Evaluation of proposed move for Water Right No 23567

Proposed: Move water right no. 23567 ID 1 a distance of 1,755 ft to the east.

Data Set: C:\Users\trevora\Documents\2020_moves\23567\23567 Current.aqt
Date: 07/15/20   Time: 14:04:24

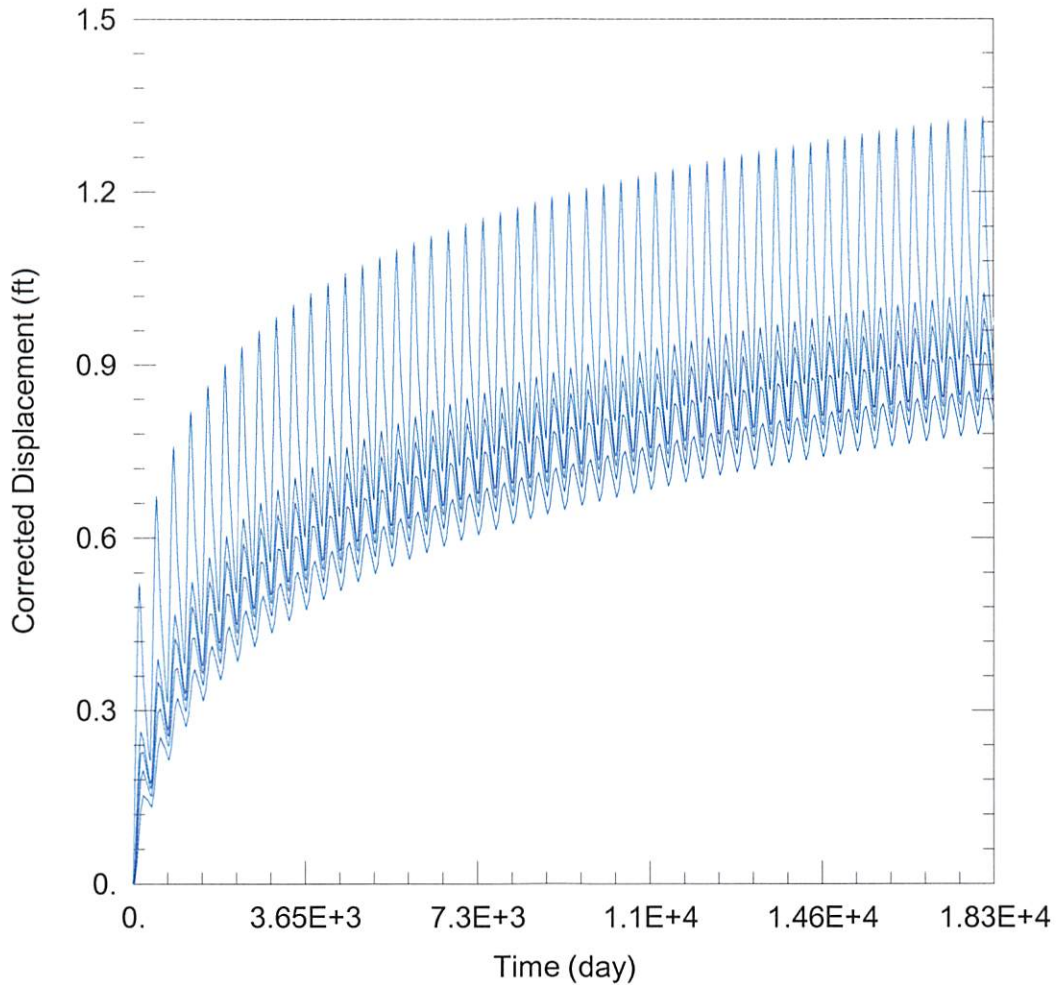
23567 ID3:	Drawdown from current location = 0.98 ft
	Drawdown from proposed location = 2.82 ft
	Net drawdown = **1.8 ft**
10487:	Drawdown from current location = 0.92 ft
	Drawdown from proposed location = 3.11 ft
	Net drawdown = **2.2 ft**

25146: Drawdown from current location = 1.03 ft

Drawdown from proposed location = 2.26 ft

Net drawdown = **1.2 ft**

Domestic 21-29-40: Drawdown from current location = 1.33 ft

Drawdown from proposed location = 2.83 ft

Net drawdown = **1.5 ft**

Domestic 16-29-40: Drawdown from current location = 0.86 ft

Drawdown from proposed location = 1.95 ft

Net drawdown = **1.1 ft**

Net drawdown does not exceed the drawdown allowance of 4.0 ft for any wells within 1 mile of the proposed location. Therefore, critical well analysis is not necessary.

Based upon information from the GMD3 model, this proposal will cause minimal effects on neighboring wells, and is unlikely to create an impairment. GMD3 staff recommends approval of the application.
